**Certificate of Appropriateness Application**

**BAR 08-10-06**

**200 E. Main Street**

**Demolition of black granite façade**

1 CANOPY REFLECTED CEILING LIGHTING PLAN

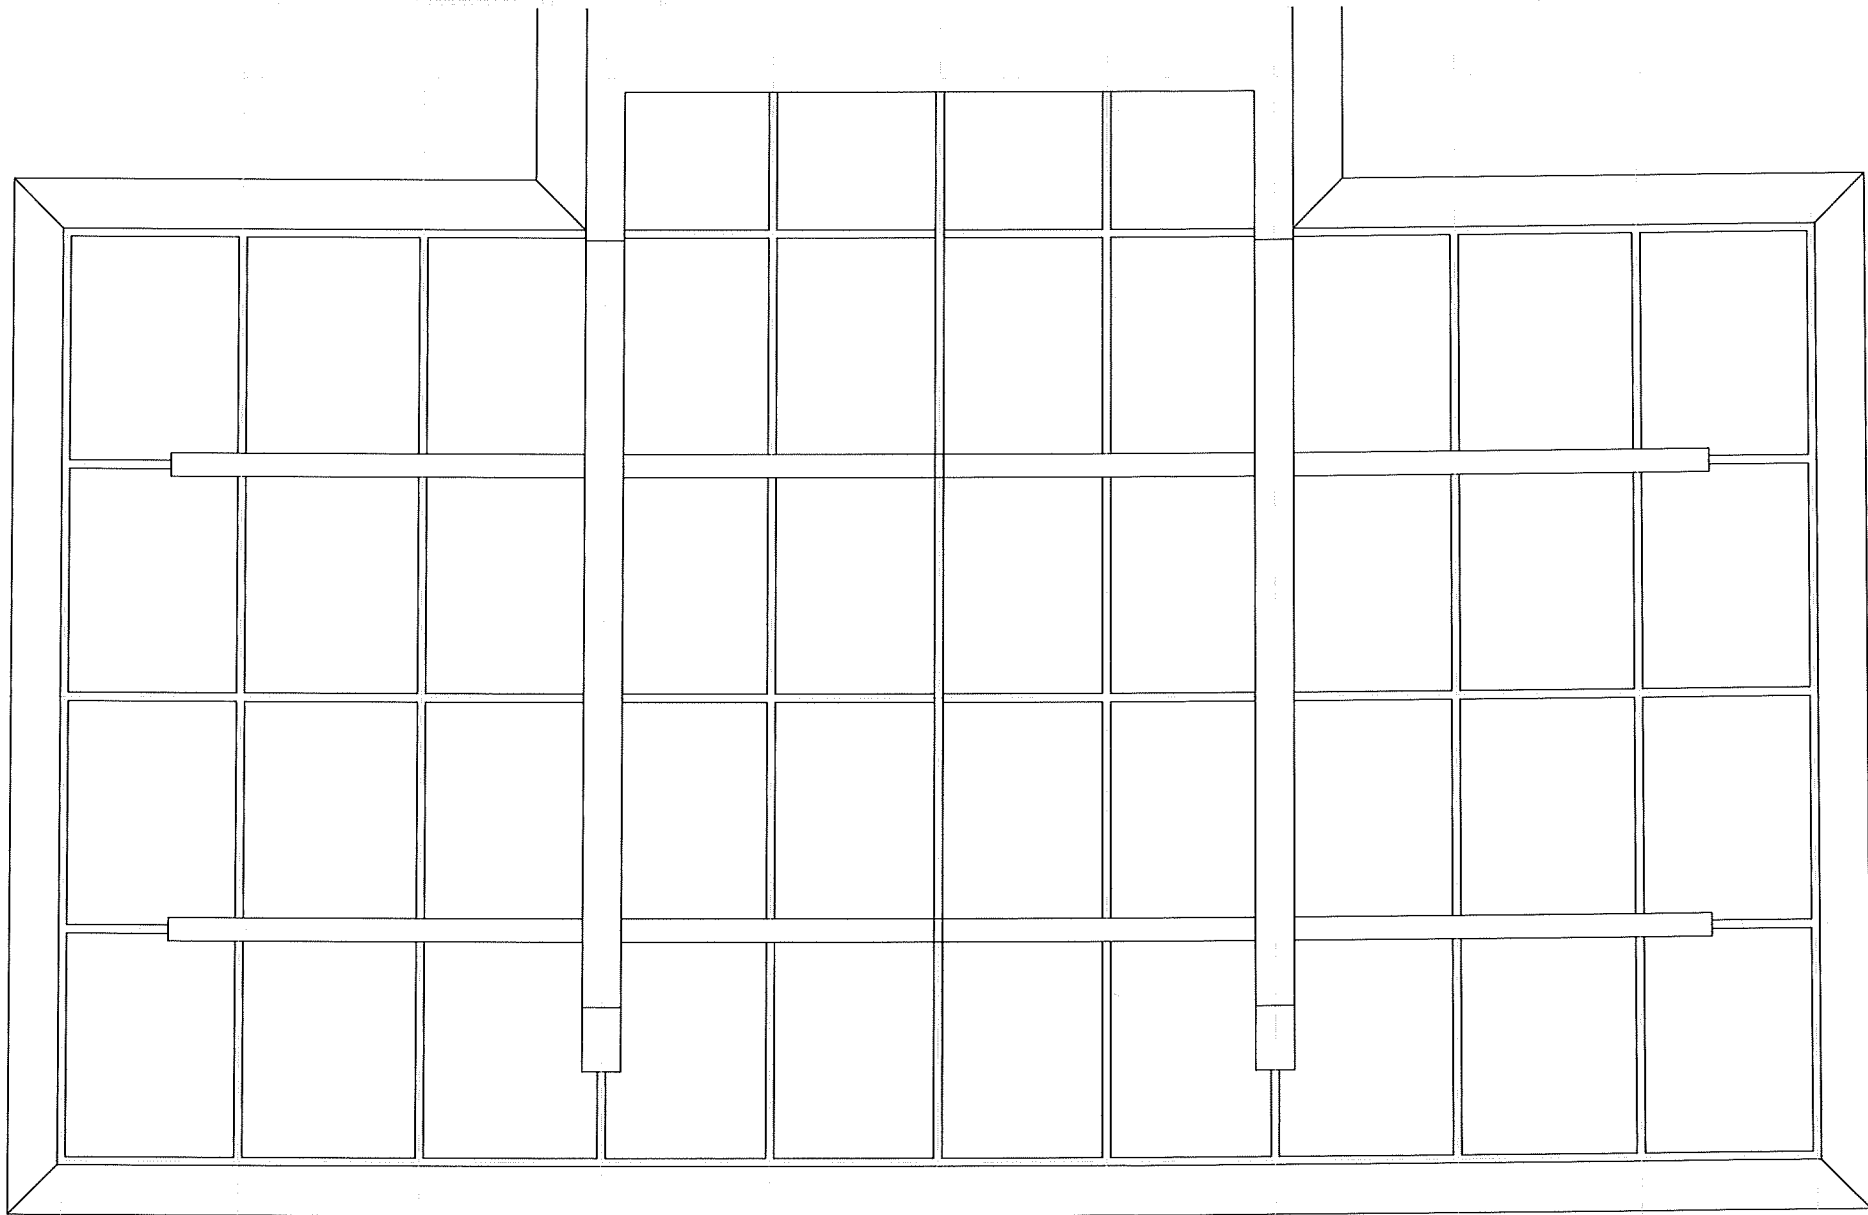
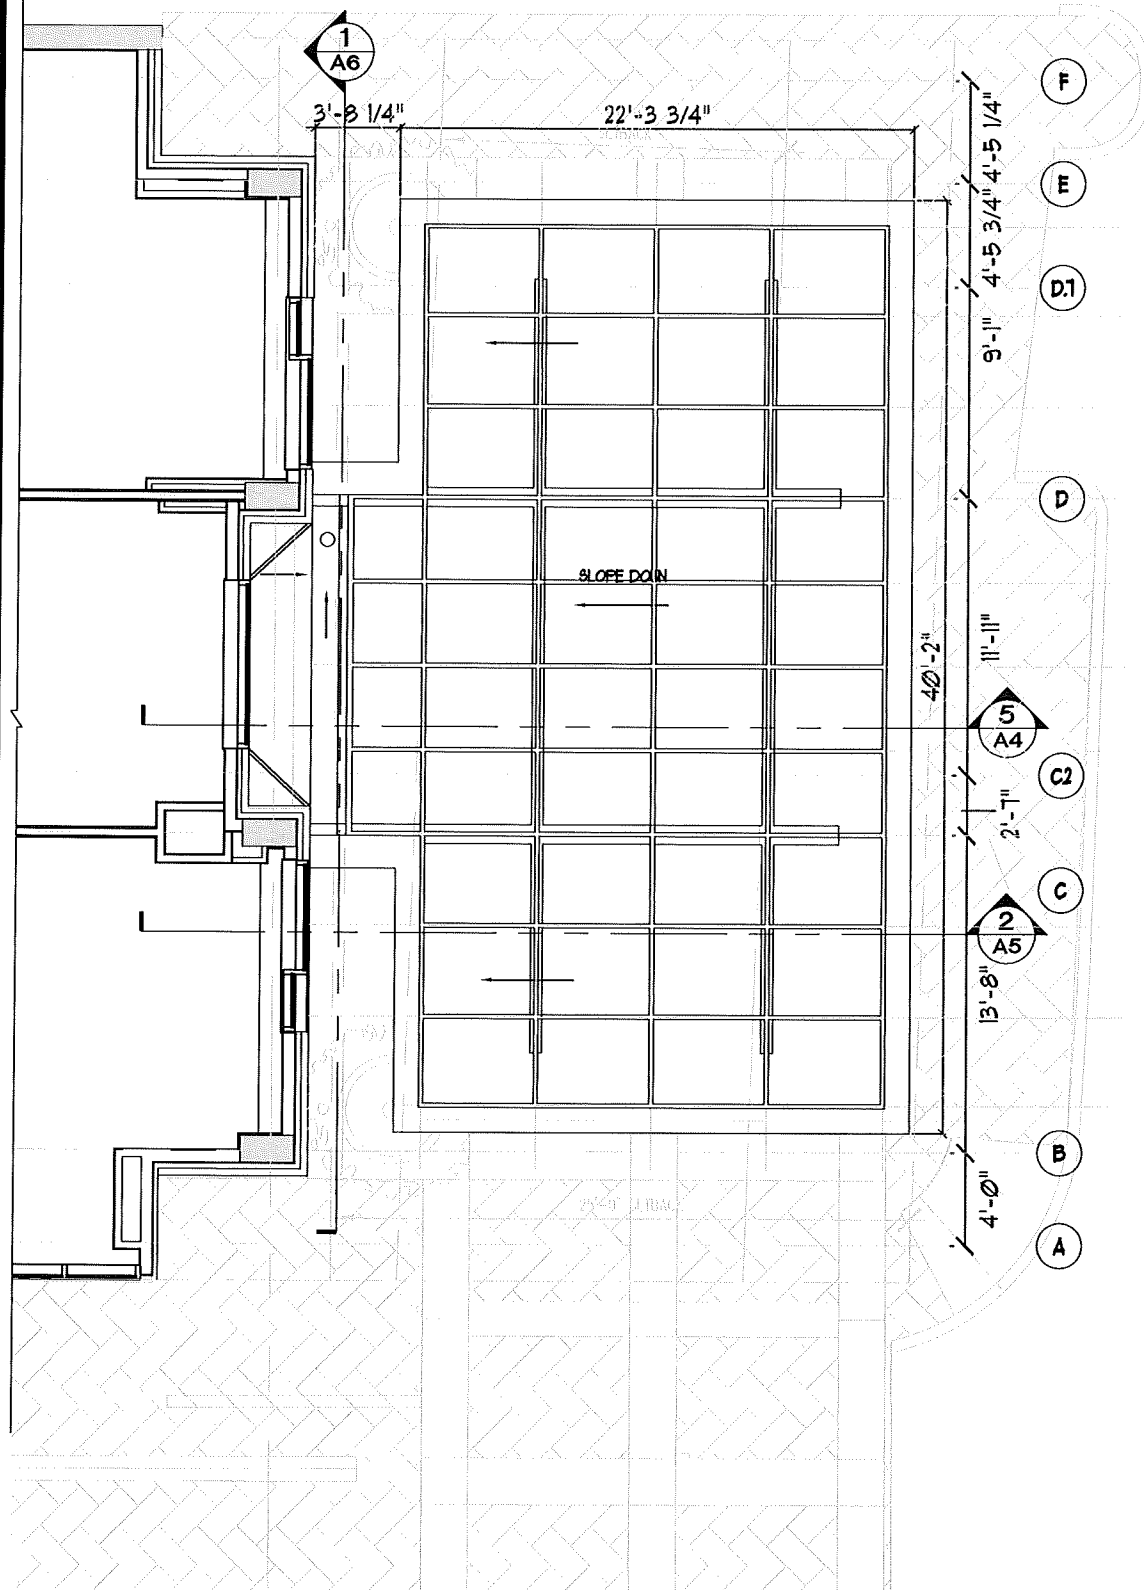
The applicant has said that the internally lit sconce lighting will meet the dark sky lumens requirements. The downlights are much preferred to the previous submittal that had internally lit canopy lighting. The applicant has submitted a photometric plan. For comparison purposes, the Illuminating Engineering Society of North America (IESNA) has established that an illumination level of 20 fc is all that is needed for service station pump islands with dark surroundings, and 30 fc for pump islands with bright surroundings. Therefore, the range under the canopy (max. 34.4) is within reason. However, per the zoning ordinance, the maximum footcandle level permitted to spill onto public rights of way is 1/2 footcandle. That amount is exceeded in front of the canopy, and should be adjusted.

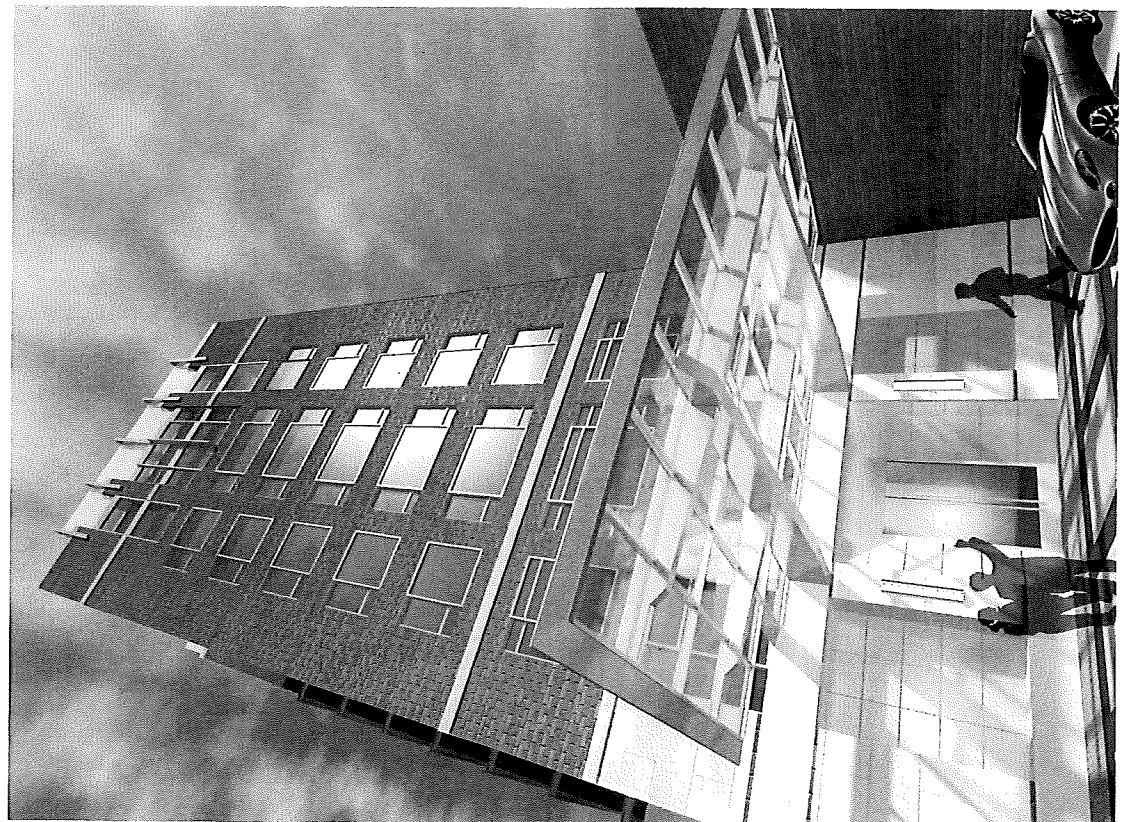
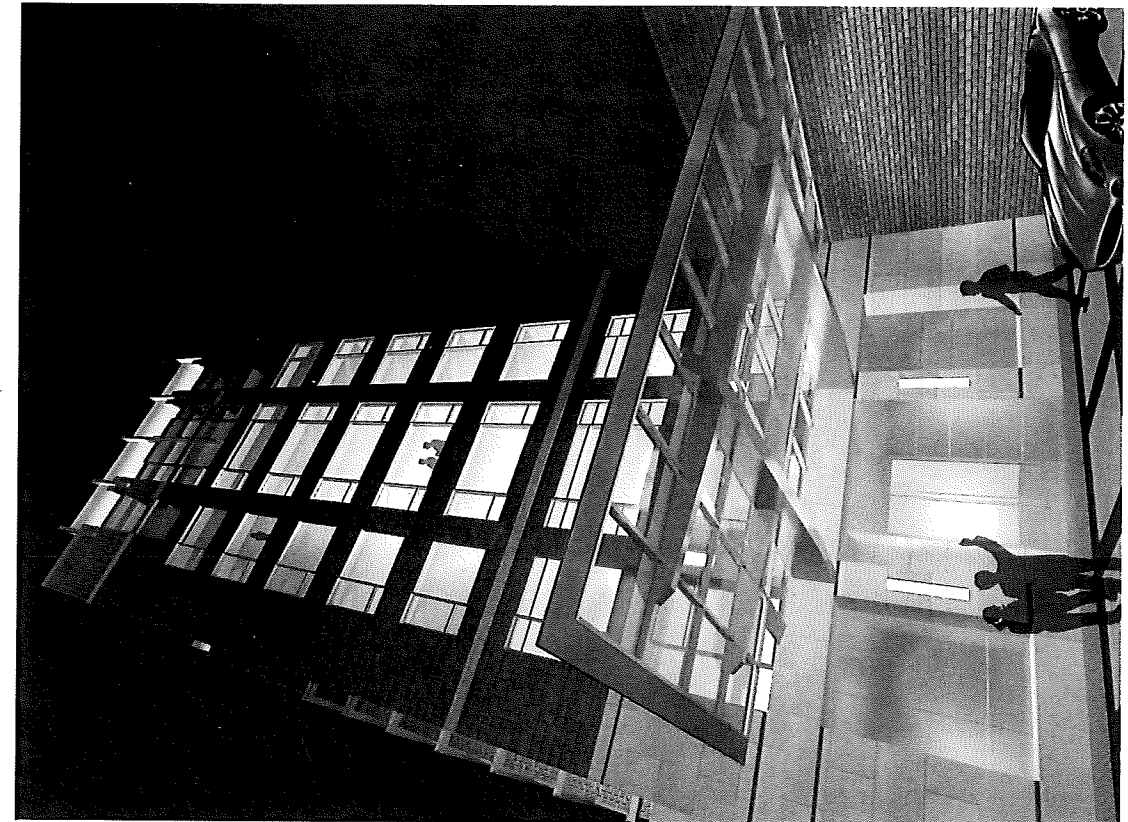
The canopy now has tapered, unadorned edges that are more consistent with the hotel design.

The BAR noted it would be beneficial if the canopy was made more consistent with the language of the existing building, specifically: the little lit medallions not found anywhere else on the building; the glass edge; the dimples on the edge; and the thickness of the edge that is greater than previously approved, and not supported by other detailing on the building.
